E4438C-18A

S E R V I C E N O T E

E4438C Option 506

DC blocking capacitor, from RLC supplier used in above identified serial number units may cause a power drop of approximately 20dBm

**Good part****Defective part**

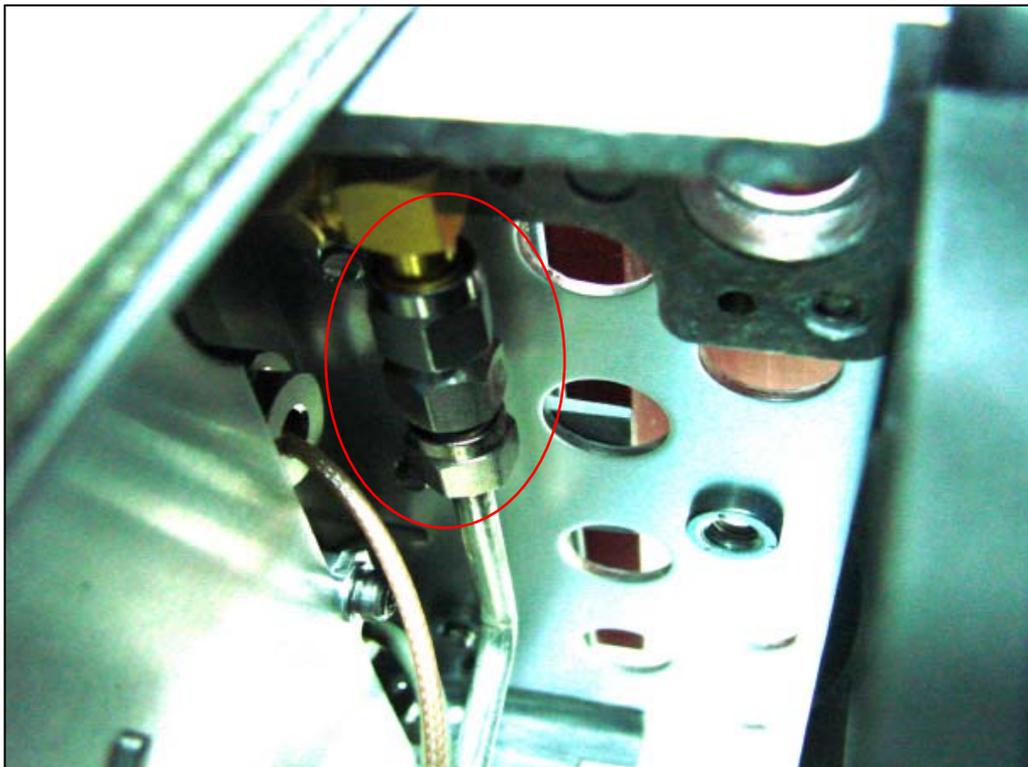
Power drop was observed on the instrument having option 506 and when operating at cold temperature (0 degree Celsius). The failure is caused by the defective DC blocking capacitor where it will show a power loss of approximately 20 dBm at low frequency setting. Repair of the assembly will be covered under warranty.

1. Repair on failure after verification that the defective part is installed inside the instrument.
2. Prevent the failure by repairing the instrument in advance. When the instrument is returned for service or calibration, check the DC blocking capacitor, by looking at the physical part. The good and defective part is shown below:-

3. Location of the DC blocking capacitor and replacement procedure. Refer to the Service Guide, Section 2 Assembly Replacement, A29 DC Blocking Capacitor. Refer to post repair procedures for A29 after replacement of blocking capacitor.
